Aug 25th , 2026

MEGT * -50&63 Profile Modification

Attachment

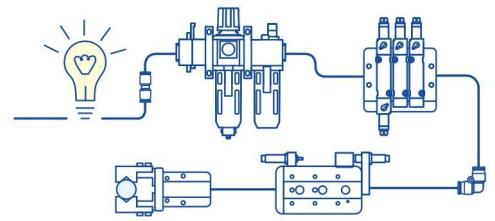
Per the Product Change Notification dated August 25, 2026, the outer dimensions of the MEQI series have been slightly increased. This modification will also affect the MEGT * series.

Dimensional details are provided in the attachment.

Before	After
MEGTX BA Type Size 50 : B2=142.5, B3=145 Size 63 : B2=150.5, B3=151.5	MEGTX BA Type Size 50 : B2=144, B3=146.5 Size 63 : B2=152.5, B3=153.5
MEGTB/U BA Type Size 50 : B2=145 Size 63 : B2=151.5	MEGTB/U BA Type Size 50 : B2=146.5 Size 63 : B2=153.5
